ITEM D4
HPO File #: HP2026_0078

1521 Columbia
Houston Heights East

CERTIFICATE OF APPROPRIATENESS

Proposal: Alteration: One-Story Addition

FRONT (EAST) ELEVATION

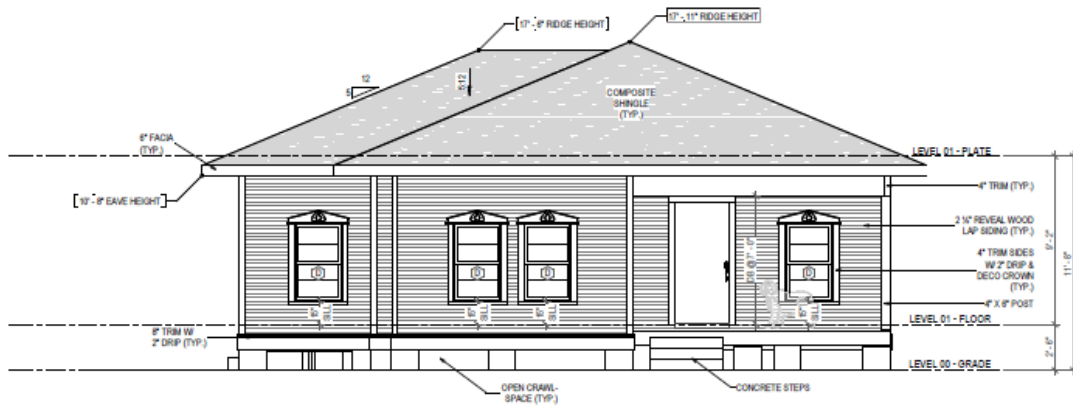
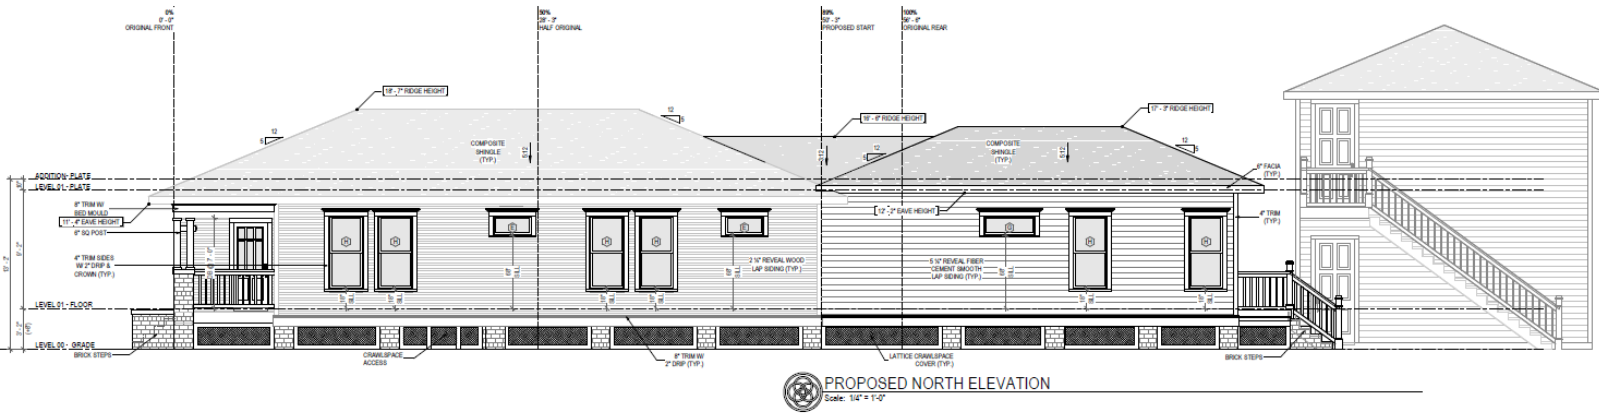
Recommendation: Approval with conditions: the front (east) elevation to feature a single tapered column at the porch rather than the proposed double-column configuration
